**TYPICAL SECTION
(CONCRETE SLAB REMOVAL
& UNDERCUTTING)**

PROJECT NAME: SOUTH BURLINGTON-WILLISTON	PLOT DATE: 3/1/2017
PROJECT NUMBER: NH 2944(1)	DRAWN BY: D. DRAPER
FILE NAME: zild340typ.dgn	CHECKED BY: J. LITTLE
PROJECT LEADER: G. EDWARDS	SHEET 13 OF 249
DESIGNED BY: D. DRAPER	
TYPICAL SECTION SHEET 2

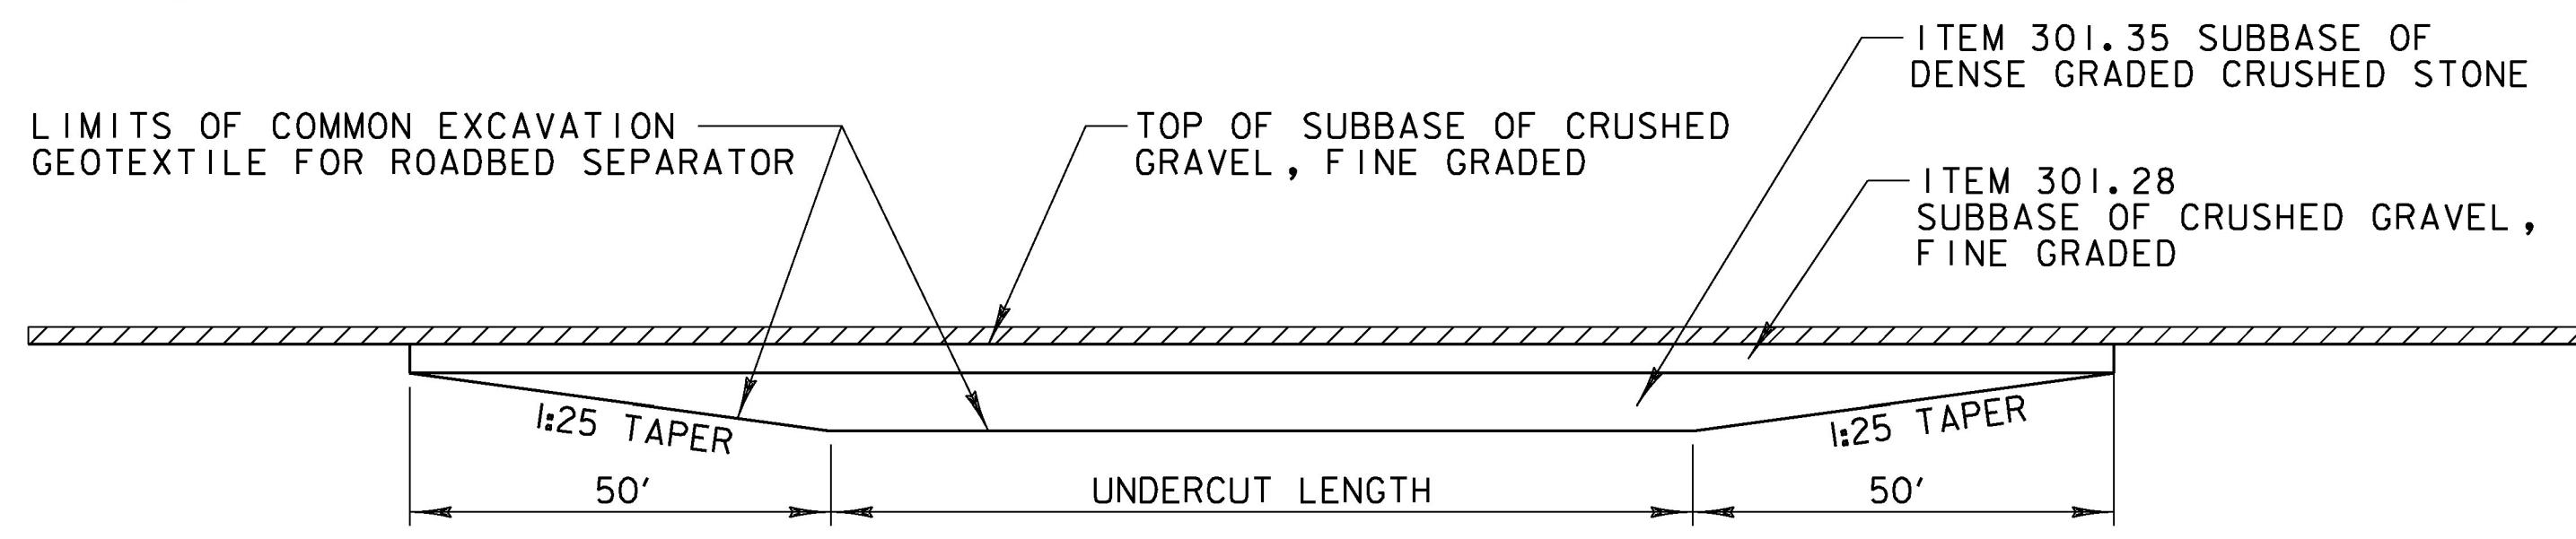
~~WILLISTON STA. 21+00 TO STA. 23+50~~
~~WILLISTON STA. 54+25 TO STA. 57+25~~
~~WILLISTON STA. 77+25 TO STA. 80+86.80~~

(SEE TRANSITION DETAILS BELOW AND ON SHEET 16)
WILLISTON 20+50 TO WILLISTON 24+00
WILLISTON 53+75 TO WILLISTON 60+75
SO. BURLINGTON 141+50 TO WILLISTON 0+26
